SALES BULLETIN

Head Studs Upgrade

Duramax Keyed Crankshaft Upgrade

HD Piston Upgrade

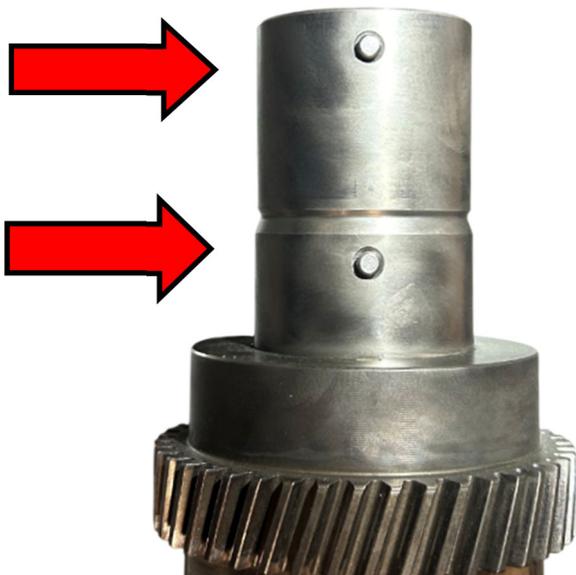
- Head Stud Upgrade—This is a durability upgrade and it increases the clamping force of the head to the block by 15% to 20%. We highly recommend the head stud upgrade on all diesel engines if available.
- Now diesel engines make over two to four times as much power as they did 20 yrs. ago, but the OE never upgraded the head bolt to a stud. The head to block fastener is under more stress than any other fastener in the entire truck so a stud is a vast improvement. The stud also puts considerably less stress on the threads in the block & it does not distort the cylinder bore as much as a bolt would, which can help with blowby issues. This upgrade is highly recommended if you do any heavy towing.

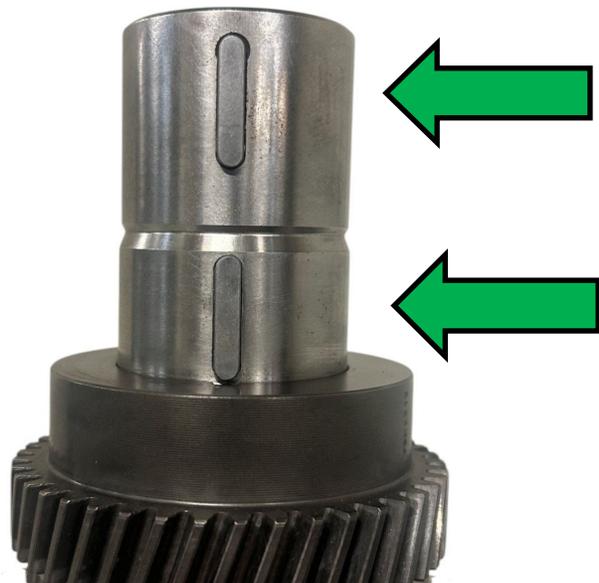
- To rule out the possibility of the factory crank dowel pin shearing off, the crankshaft was cut for a keyway and fitted with a steel bar (known as “keying the crankshaft”).
- This is common practice for any Duramax build, as the 5mm dowel pin that holds the harmonic balancer and oil pump drive gear in place is known to shear off the snout of the crankshaft in heavy duty applications. Once this failure occurs the engine self destructs in short order, so “keying the crankshaft” is the ultimate insurance policy to prevent this from occurring.
